Plan Commission

SUBJECT: Review and Recommendation on the Site Plan for 600 and 633
Heritage Rd for an Expansion at Belmark. Applicant: Robert E. Lee
and Associates

Item 3: Review and Recommendation on the Site Plan Application for 633 Heritage Rd for an Office Expansion to Belmark Plant #3 and Skywalk. Applicant: Robert E. Lee & Associates

RE: Application for Site Plan Review
Belmark, Inc
Plant 3 – Office Addition and Skywalk
Plant 1 – Office Renovation

TITLE		EXISTING CONDITIONS AND DEMOLITION PLAN	
DRAWN	LLP	CHECKED	PHK
DATE	02/08/2016		
SCALE			
DRAWING NO.	C1.1	PROJECT NO.	15147

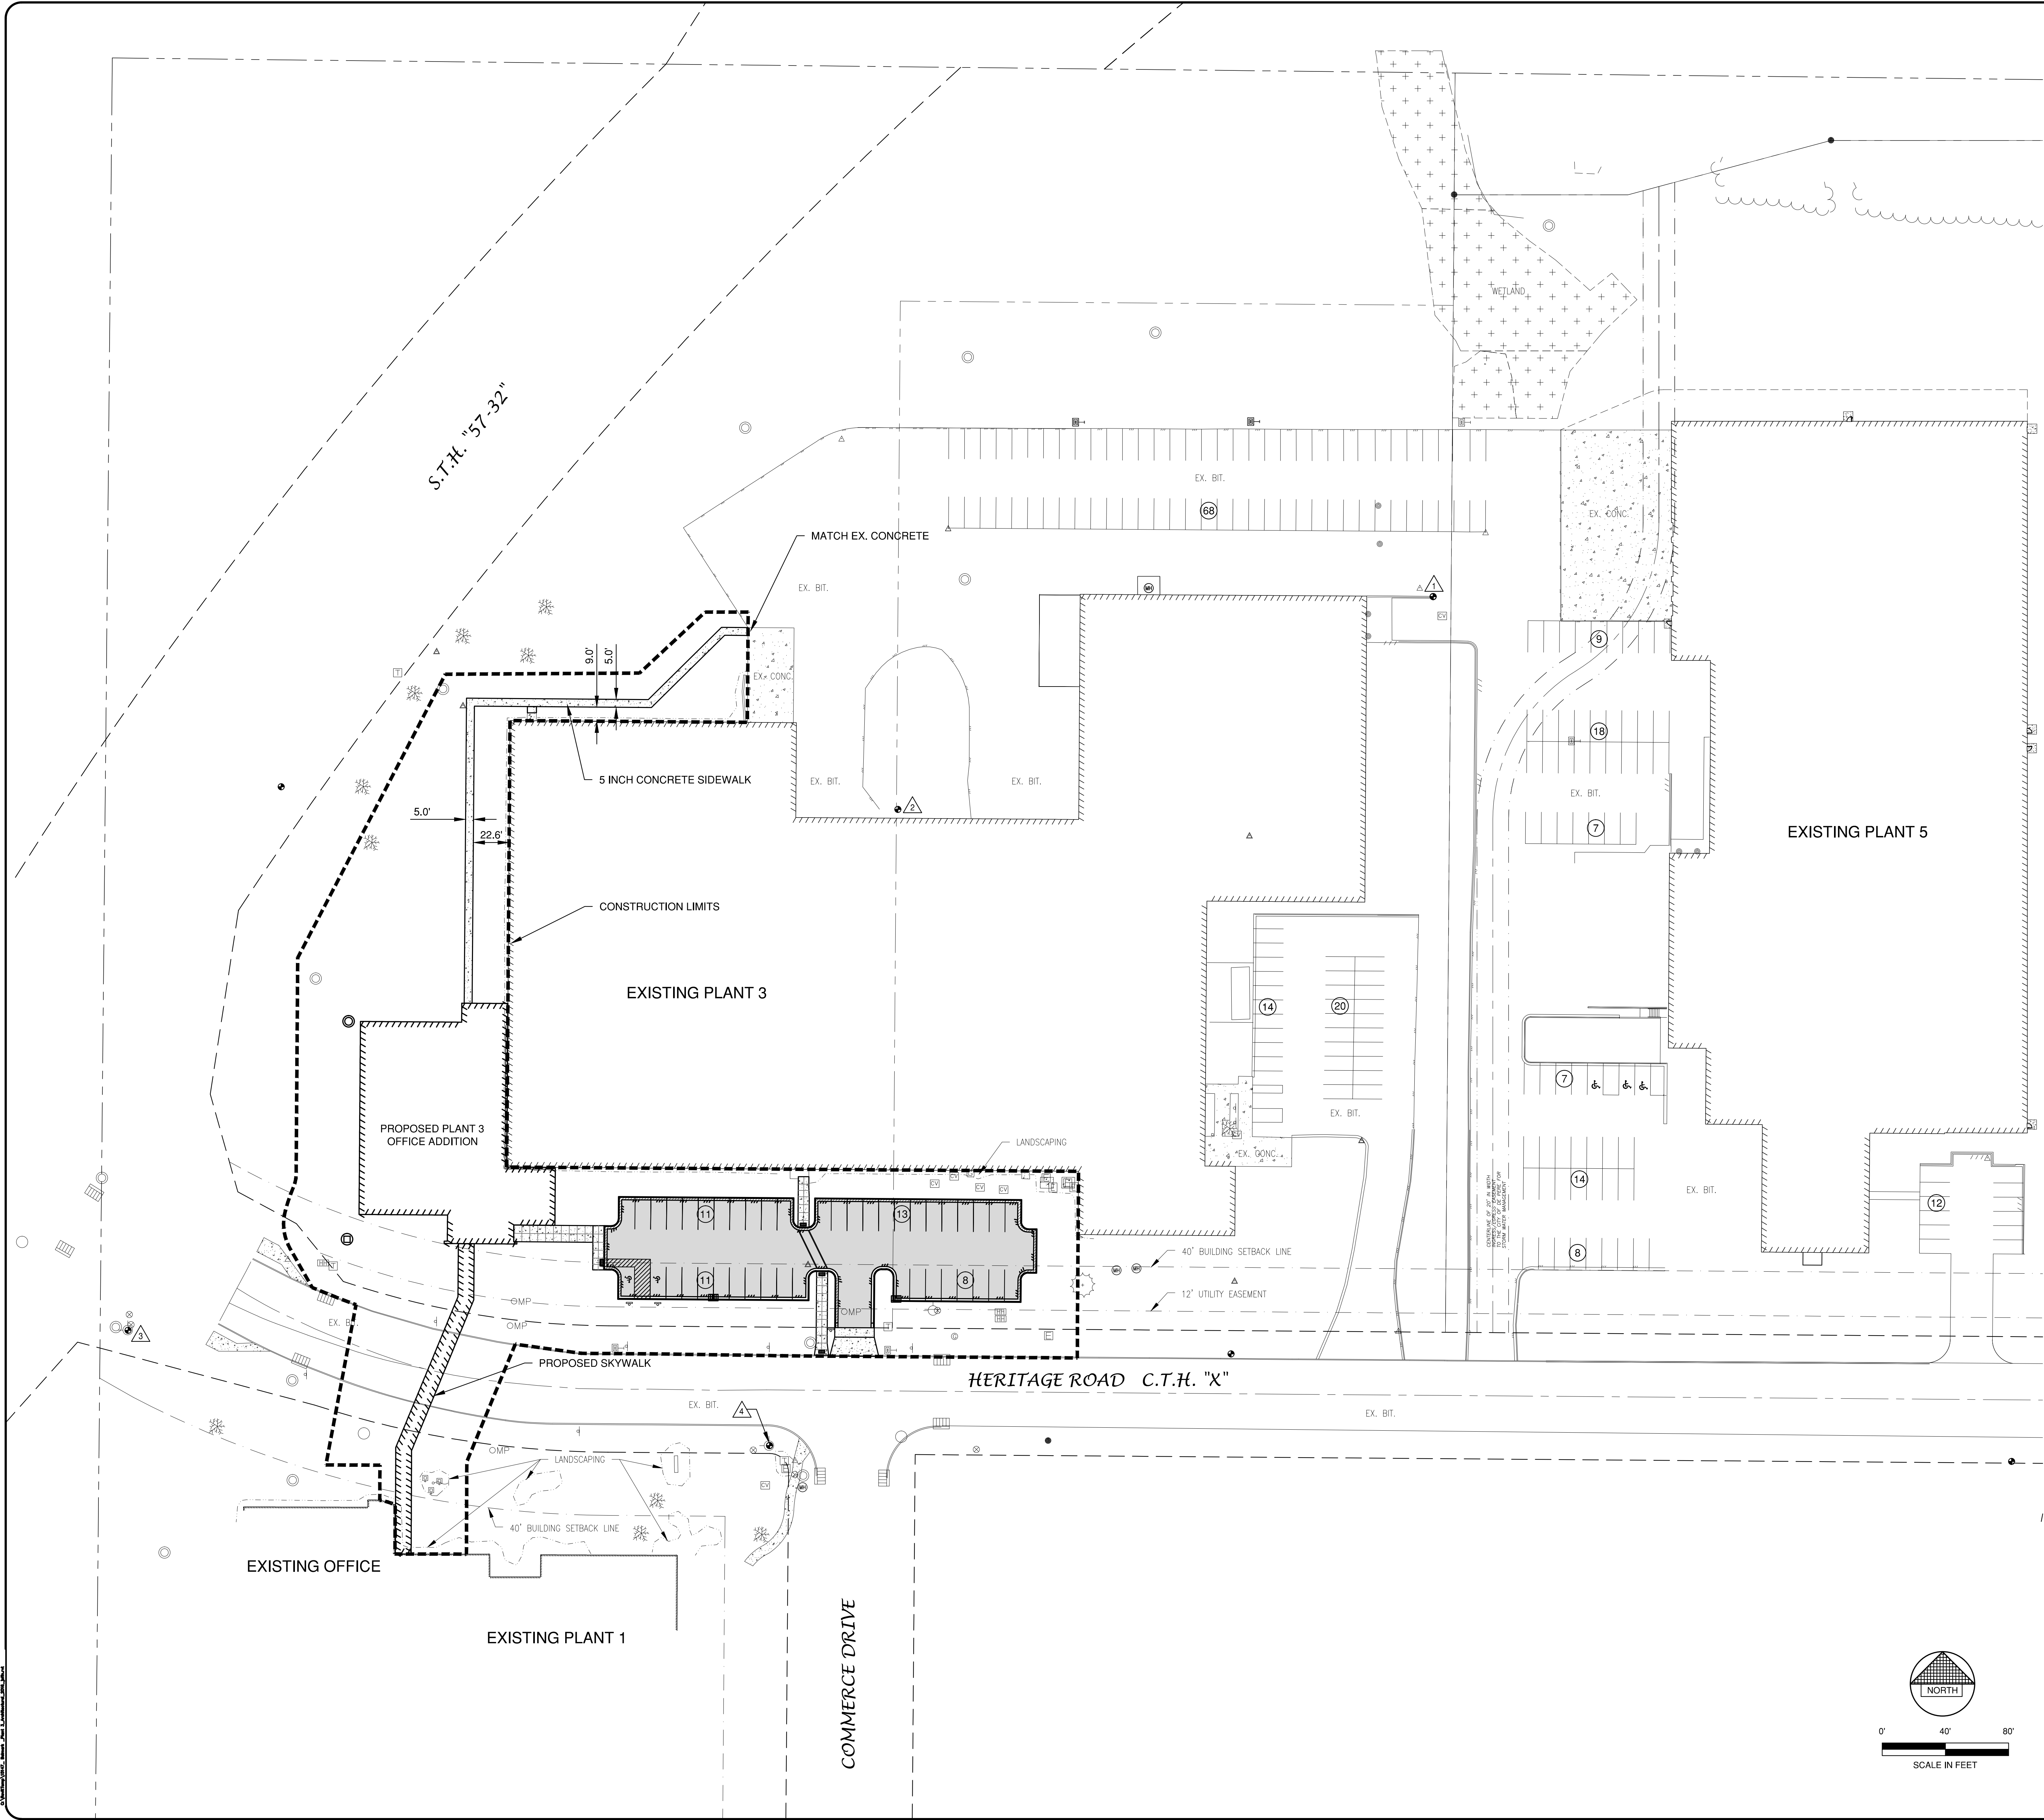
7. Update the lighting Plan to show the proposed lighting site does not exceed 1.0 foot candle at the property line.
8. The Existing Conditions identify Heritage Road as Ex. Bit. Update the plan to show the roadway, east of the roundabout is concrete pavement.

DETAILED SITE PLAN

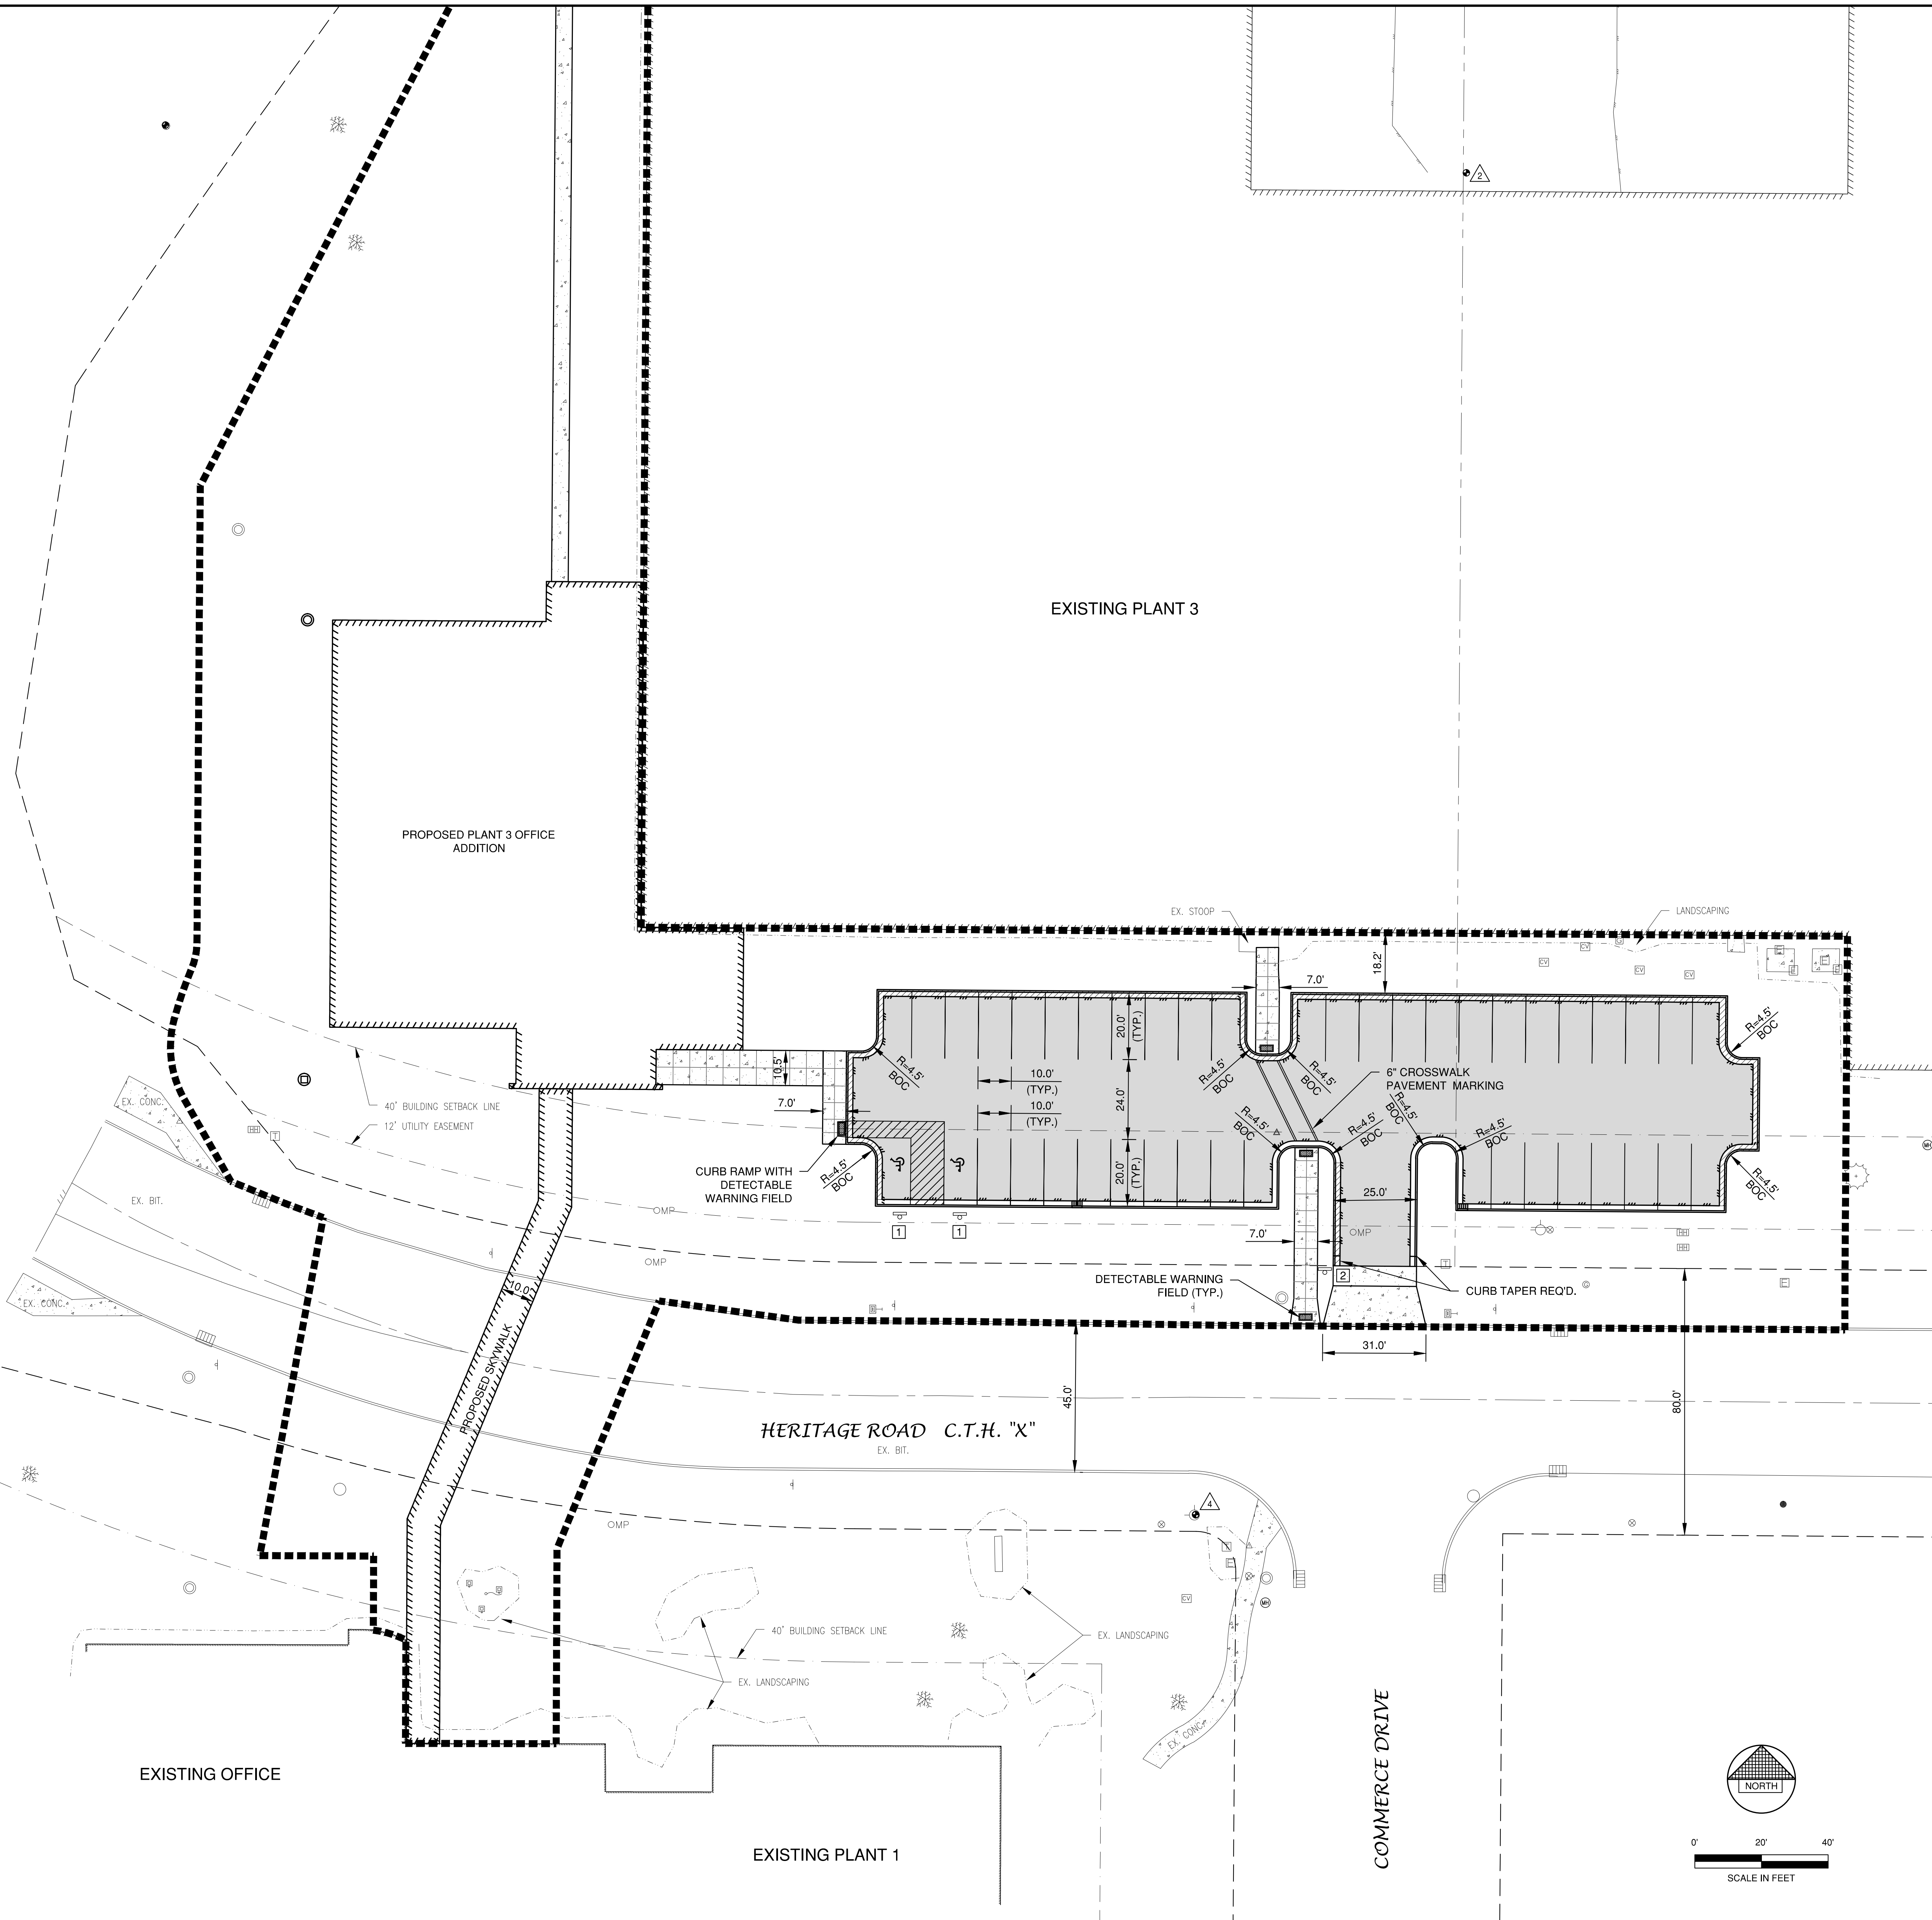
1. A 6" sanitary sewer lateral is shown. Make the connection to the existing 21" pipe with a wye fitting and in compliance with the City of De Pere construction specifications.

2. Note on the plan that, "All taps to the City sewer main are to be completed under the observation of City personnel".
3. Note on the plan that the utility connection made within the street right of way will require a City of De Pere street excavation permit.

4. No new water service connection is shown on the plan.
5. The storm water will be treated by the existing detention pond, the plan did account for additional development in the watershed.

6. Brown County Highway Department will review and approve the skywalk, the at-grade pedestrian crossing and new driveway curb cut. The driveway will be constructed to City standards and include a sidewalk section as shown in Drawing C-1 of the City of De Pere Standard Construction Specification.

9. Show dimensions of adjacent streets and right of ways.
